PETITION FOR SPECIAL EXCEPTION

The undersigned, legal owner(s) of the property situate in Baltimore County and which is described in the description and plat attached hereto and made a part hereof, hereby petition for a Special Exception under the Zoning Law and Zoning Regulations of Baltimore County, to use the herein described property for _____ Class B Office Building in R-O Zone _____

SPODAK OFFICE BUILDING

PROJECT NAME: Spodak Office Building
PROJECT NUMBER: 85079
LOCATION: 1018 Dulany Valley Road
DISTRICT: 9C4

FUTURE STAIR WHEN SECOND FLOOR IS OCCUPIED

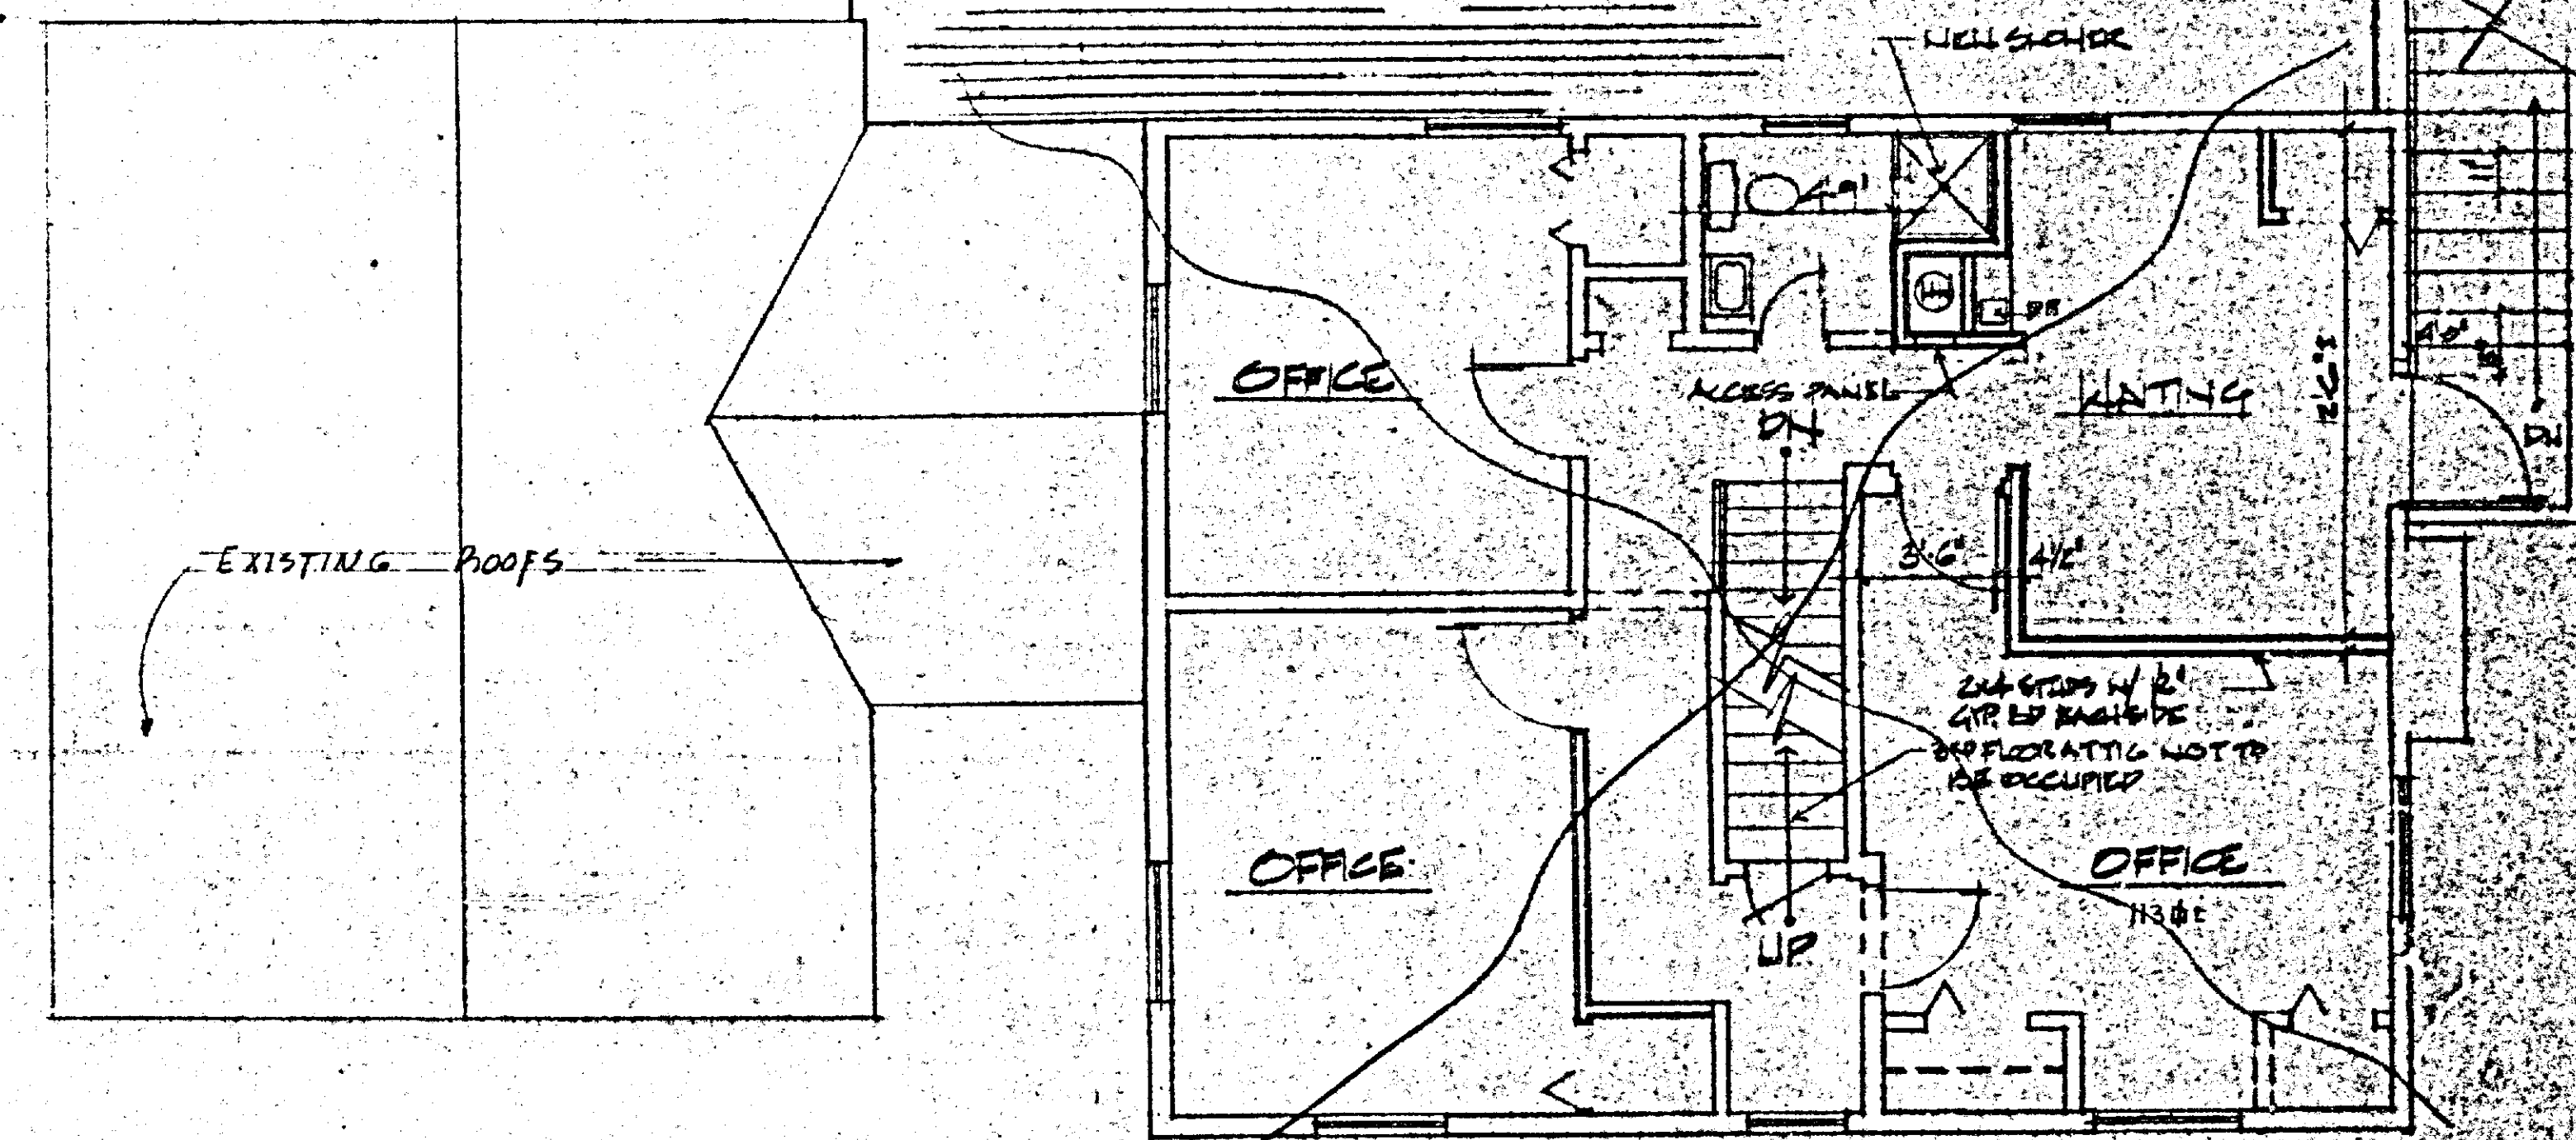
F. The structure does not appear to comply with Table 505 for permissible height/area. Reply to the requested variance by this office cannot be considered until the necessary data pertaining to height/area and construction type is provided. See Table 401 and 505 and have your Architect/Engineer contact this department.

- (✓) 1. A change of occupancy, alteration, and other miscellaneous permits are required.
- (✓) 2. Floor loading of 50 pounds live load design are required. Have a registered in Maryland structural engineer provide a letter of certification. See Section 903.0, 904.0, 905.0, Table 906.0, 907.0.

- (✓) 8. Exit stairs, handrails, etc. shall comply with Section 816.0.
- (✓) 9. Plan does not show the following handicapped requirements under the State Handicapped laws:
